Subject: **CORRECTING VERTICAL SEAM IN
 SCREEN CENTER**

Model: **PVM-1942Q/1943MD/1944Q**

**THIS REVISION SUPERSEDES TECHNICAL
 BULLETIN 92-072 DATED JUNE 1, 1992**

Figure 1

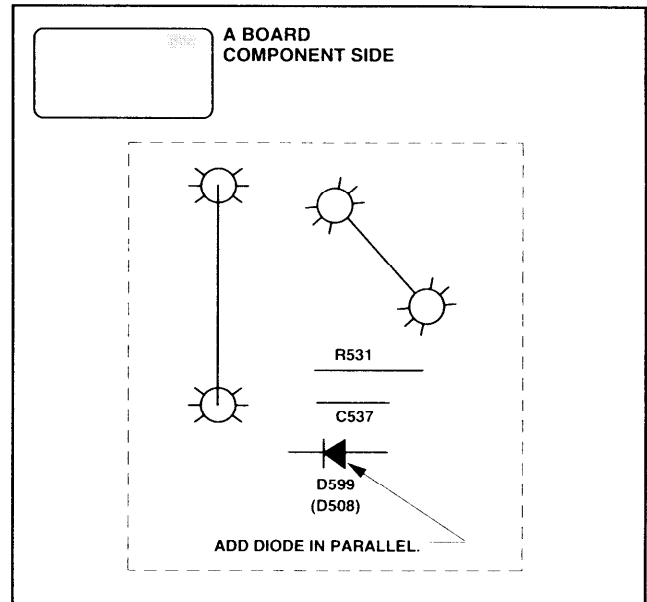
When receiving an all-white signal, or when screen contrast is high, a vertical seam may be visible in the center of the screen. To correct this condition, solder a diode in parallel to D599 on the A board (component side, zone B-1) as shown in Figure 1.

NOTE: On earlier units, D599 is marked as D508 and has the same pattern.
